## Response to Referee #1

This manuscript describes the development of the MOSART river transport model to include a flood inundation scheme which was then tested across the Amazon basin. Excellent detail is given as to the setup of the model including the processing of the DEM and channel geometry parameters. The model is run for a time period longer than 20 years and evaluated against in-situ streamflow observations and remotely sensed satellite data of river stage and flood extent. Results from the evaluation showed good agreement in each of these aspects. A sensitivity analysis was then conducted to assess the impact of the DEM and channel geometry corrections, setting a uniform Manning's  $n$  and using a kinematic channel flow equation. Sensitivities were found in each variable due to the influence they have upon the floodplain elevation, channel capacity and flow velocity.

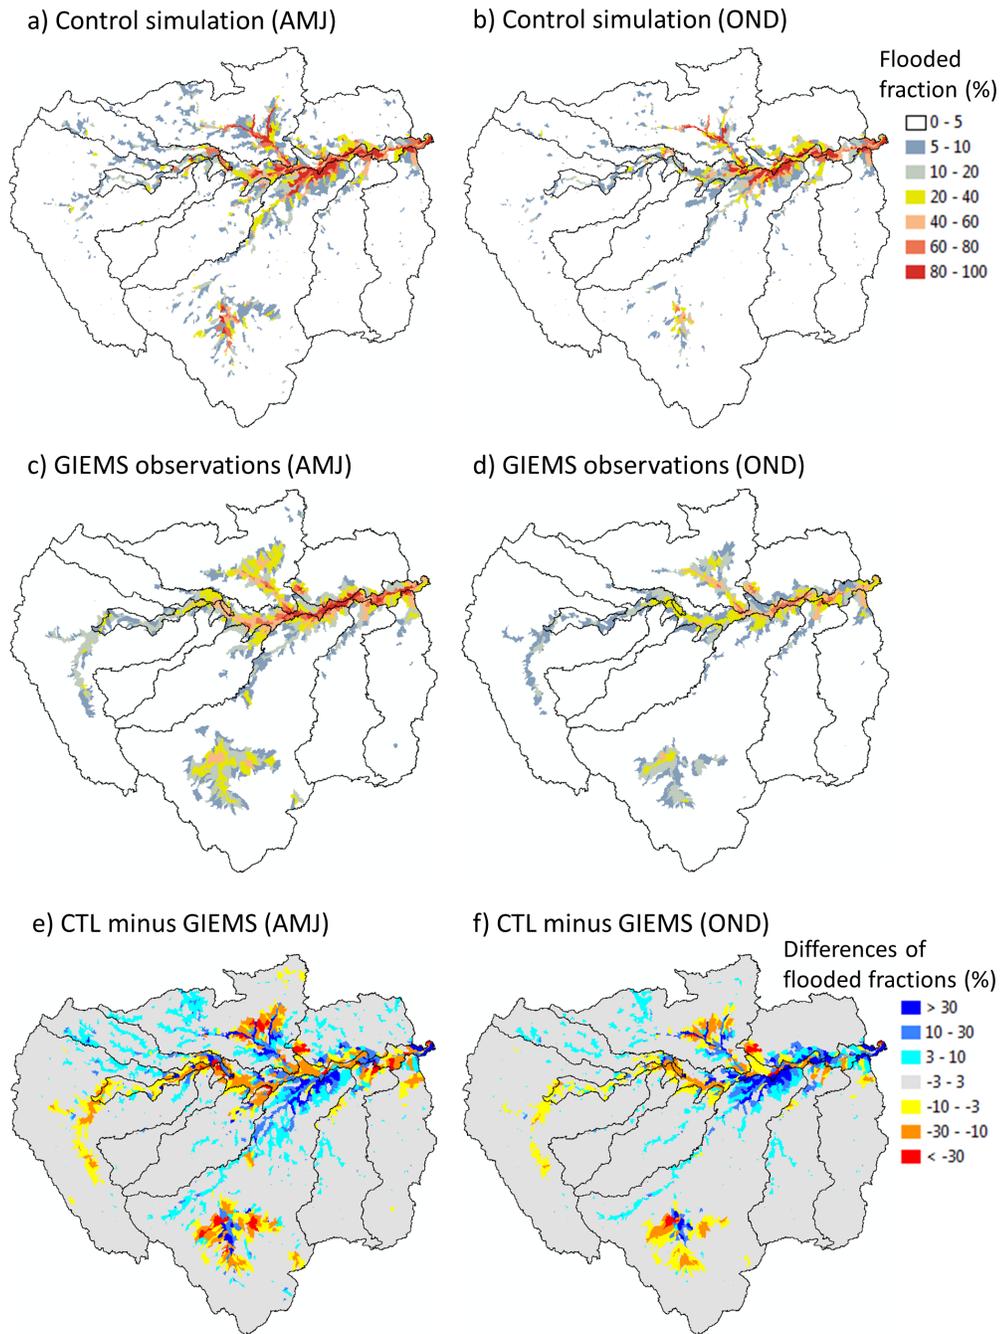
Figure 6 the four plots should be replaced with two difference plots, one showing the difference between the simulated and observed during high water and the other during low water. This would better visualise the difference between the two simulations.

Page 13 line 13 the statement that the GIEMS data and simulation agree reasonably well is very vague. Figure 6 appears to show that the simulation overestimates the extent in the lowland portion of the basin, especially at low water. This sentence should be expanded to include more details about where the differences occur.

Reply: Fig. 6 will be supplemented by two panels showing the differences during high water season (Fig. 6e) and low water season (Fig. 6f). The original four panels were kept in order to show the spatial patterns of inundation. Please find the revised Fig. 6 in the Appendix of this response.

Reply: We will add some discussions of the differences between model results and GIEMS data in the revised manuscript.

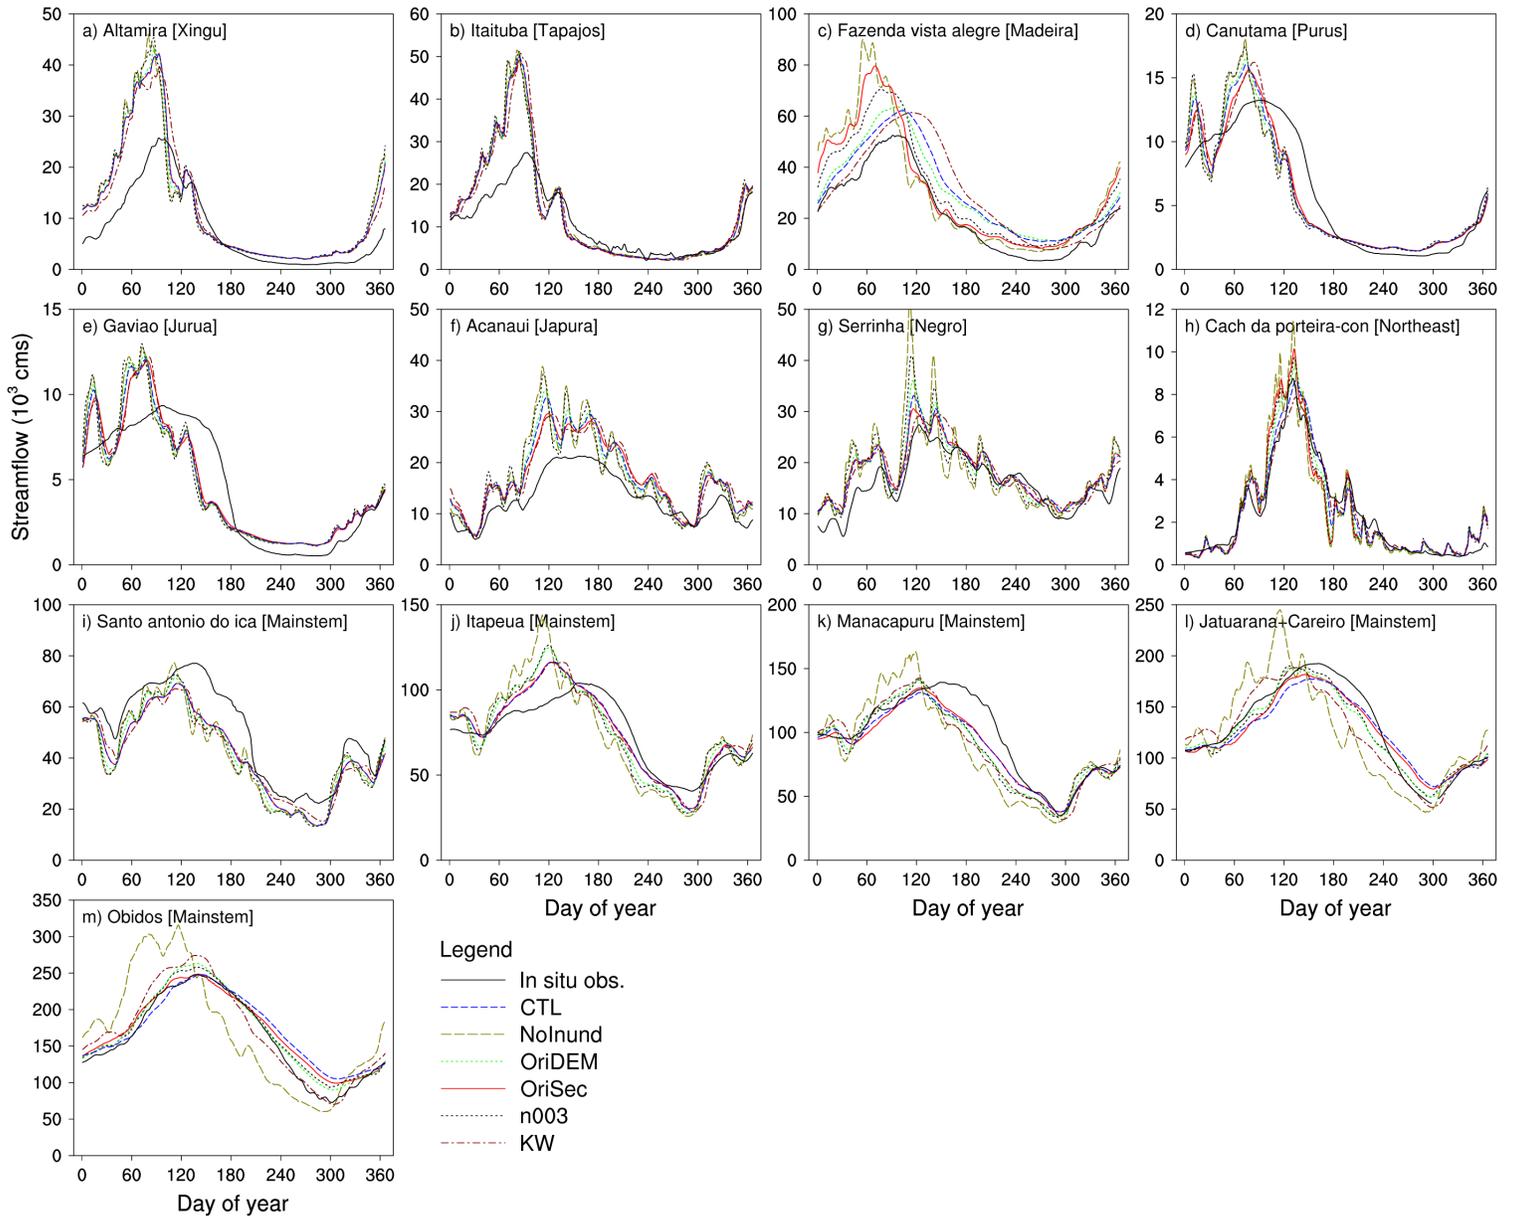
Figure 8, why does this figure refer to the average seasonal cycle from 1995-2006 whilst figures 9 and 10 refer to 2007 only? Does this explain why the results for the kinematic simulation are so different between figures 8 and 9 & 10? I would expect the kinematic simulation to be very different to the control simulation (as it appears in Figs 9 and 10), yet does this not appear to be the case for streamflow - could the authors explain why streamflow is not sensitive to the kinematic solution or replot Fig 8 for 2007 only so that it is directly comparable to Figs 9 and 10?

Section 4.2, the greatest effect is shown in the Madeira basin, is this most likely because the multiplicative factor (0.36) has the greatest effect on changing the channel geometry relative to the other basins? This should be stated more explicitly in the second paragraph.

Reply: Figs 8, 9 and 10 have been replotted to show the results of the same year. We did not have observed streamflow data for year 2007 so we plotted the results of another year (2005).

The three figures show that the differences in streamflow between the simulation KW (kinematic wave method) and the simulation CTL (diffusion wave method) are not as evident as those in river stages. Previous studies have yielded similar results (e.g., Yamazaki et al. 2011: Fig. 5). The reason could be that the flow velocities in the simulation KW (which are based on riverbed slopes) are also quite different from those in the simulation CTL (which are based on friction slopes). Please see the revised figures in the Appendix. Note that as mentioned in our reply to [C1-3], these figures have also been updated to include the results from a simulation without the inundation parameterization.

Reply: Yes, the reason is that the channel geometry changes in the Madeira subregion are larger than those of the other subregions.

- (1) “*channel geometry changes*” was replaced with “*the channel cross-sectional area is multiplied by a factor of 0.36 (Table 1)*” ;
- (2) Added one sentence: “*Similar phenomenon is observed at the gauge “Cach da porteira-con” in the Northeast subregion (Fig. 8h), where the channel cross-sectional area is multiplied by a factor of 0.48.*”
- (3) Added “*caused by refining channel geometry*” after “*Inundation changes*”.

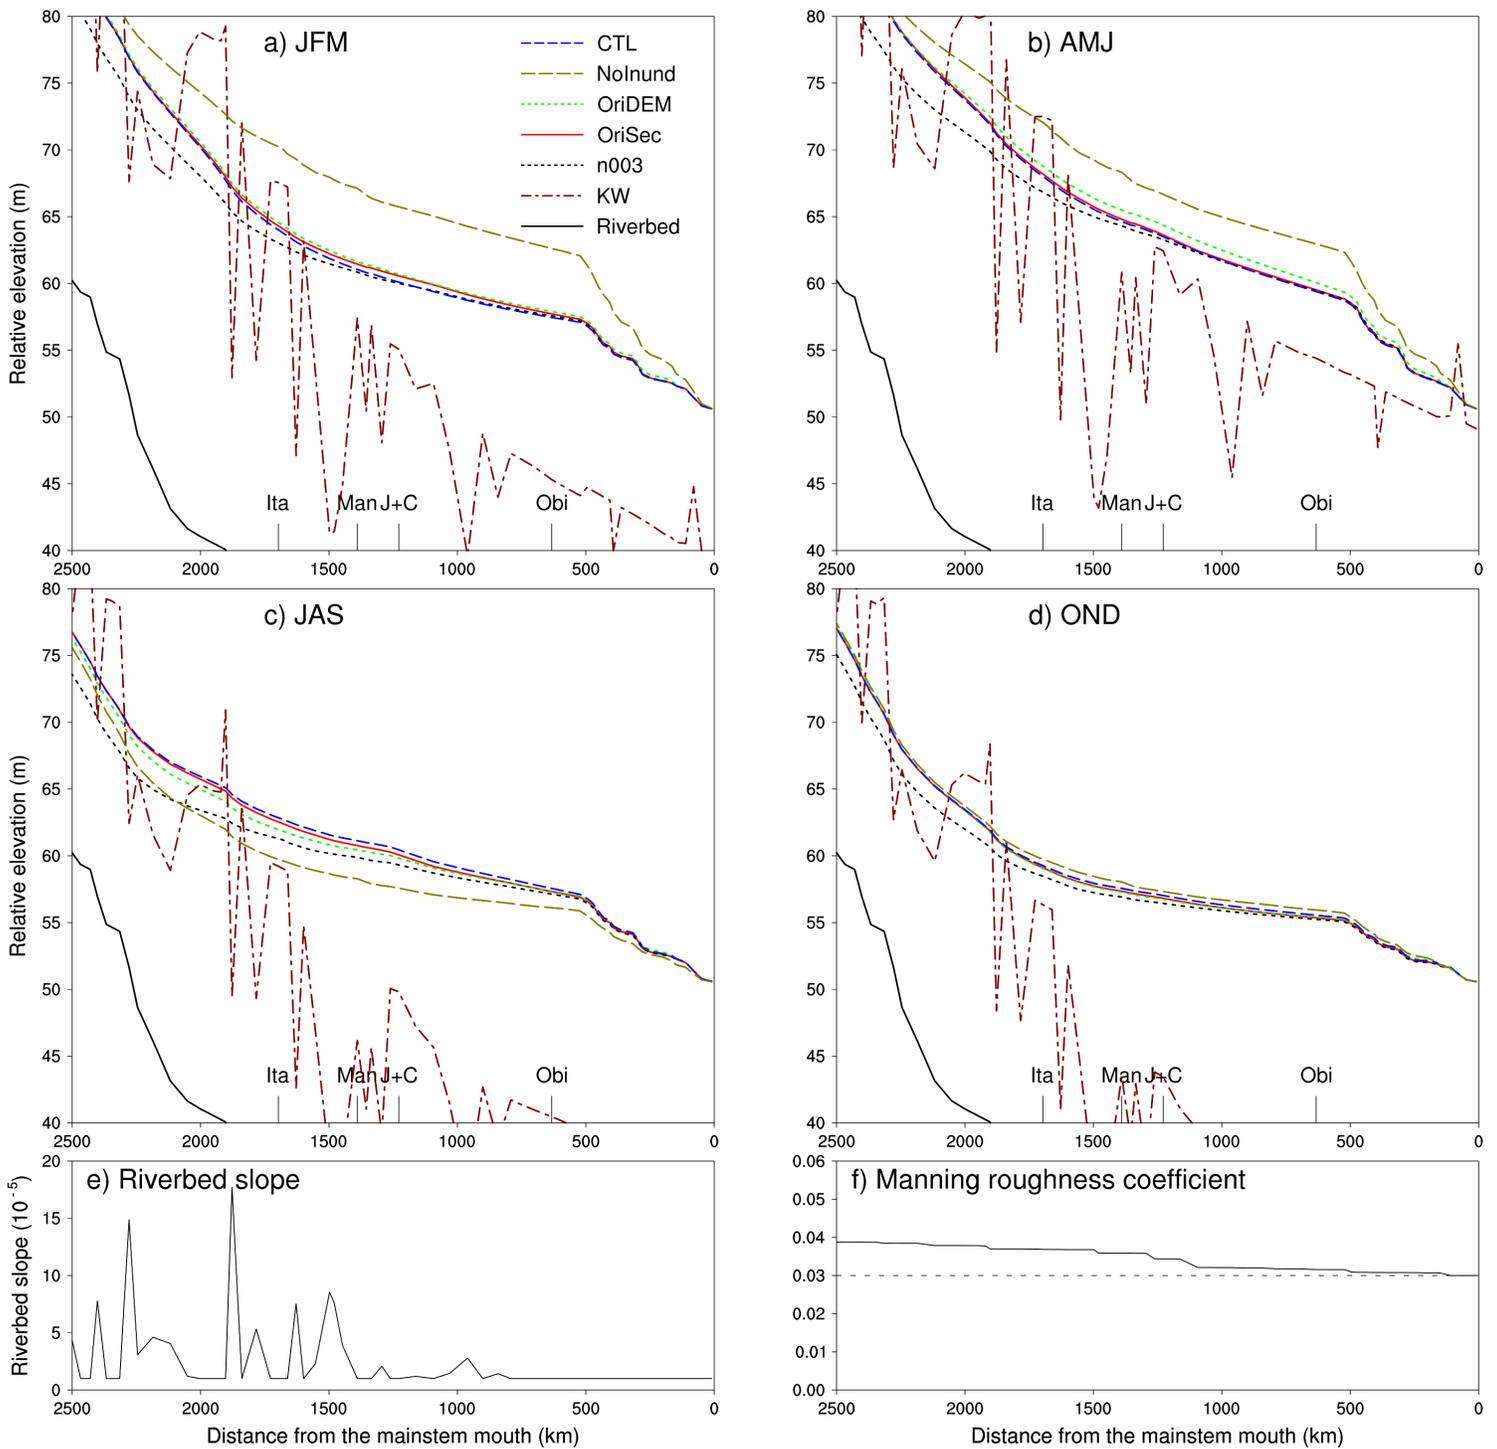
Figure 10 is confusing with the y-axis reset for 0-1500 km for the simulations but not for the riverbed profile. These graphs should use the same y-axis for the entire river length in order to remove the confusing jump that happens at 1500 km.

Reply: Figure 10 has been replotted to use the same y-axis for the entire river length and will be updated in the revised manuscript. We thank the reviewer for the suggestion. Please find the revised Fig. 10 in the Appendix of this response.

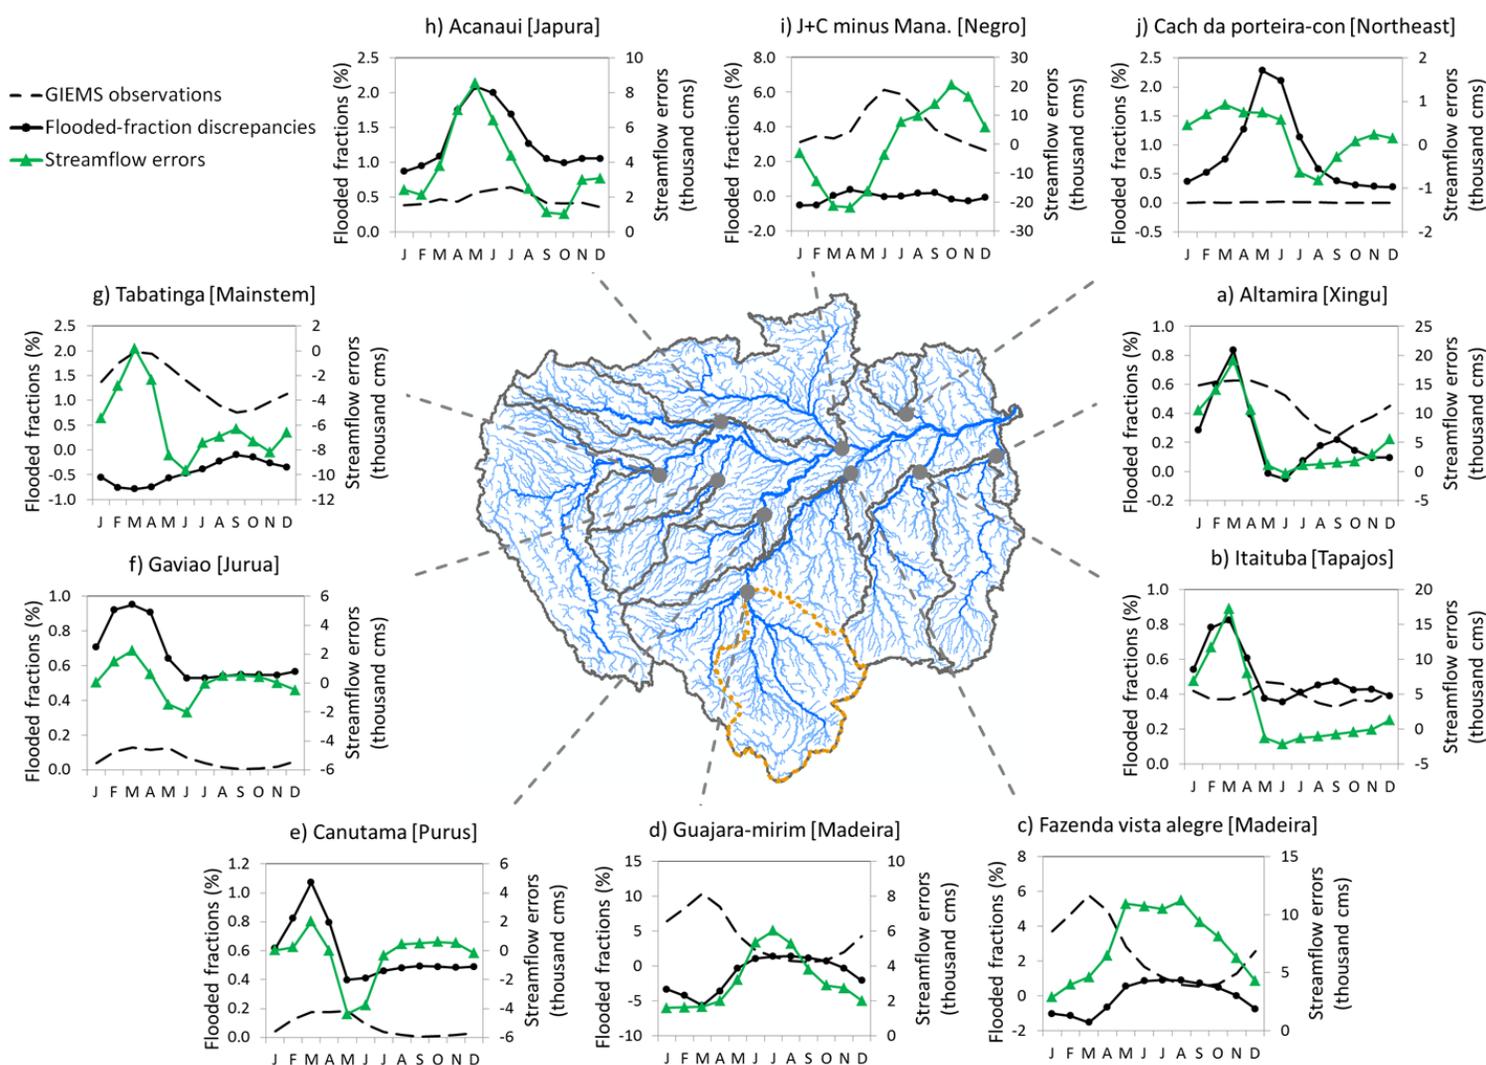
Figure 7 it could be useful to plot the data by seasons e.g AMJ, JAS, OND, JFM as this might show if the errors are concentrated in a particular season e.g. low water.

Reply: Thank you for the suggestion. Similar to Figure 7 that compares the annual averaged biases in flood extent and streamflow, we plotted the averaged monthly streamflow errors and the flood extent discrepancies (i.e., the differences between simulated flood extent and the GIEMS data) during 12 years (1995 – 2006). Please find the figure at the end of the Appendix. This figure shows that the seasonal distribution of streamflow errors varies for different gauges. For example, for “(a) Altamira” and “(b) Itaituba”, evident positive biases occur from January to April; for “(c) Fazenda vista alegre” and “(d) Guajara-mirim”, positive biases are more evident from about May to October; for “(h) Acanauí”, positive biases are more evident from about March to July. Except for three subregions (Negro, Cach de porteira-con, and Tabatinga), the seasonality of flood extent discrepancies follows the seasonality of streamflow errors very closely, indicating the important contribution of streamflow errors to flood extent biases on seasonal time scale.
